## PCN – Process Change Notification

| Change: | TI.18.3113 |

| Model#   | Part Number | Changes  |
|--|-------------|--|
| 868MHz Terminal<br>Antenna 3dBi SMA(M)<br>Hinged 90 degree | TI.18.3113  | Changed tolerance of antenna housing from 1.2mm to 10mm. |

**Illustration of Change**

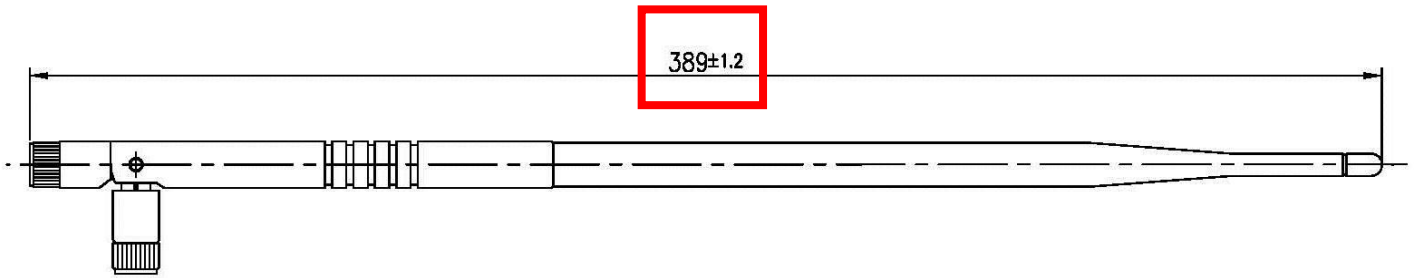
Tolerance in material created by its softness creating variation in production, so changed tolerance of antenna housing from 1.2mm to 10mm.
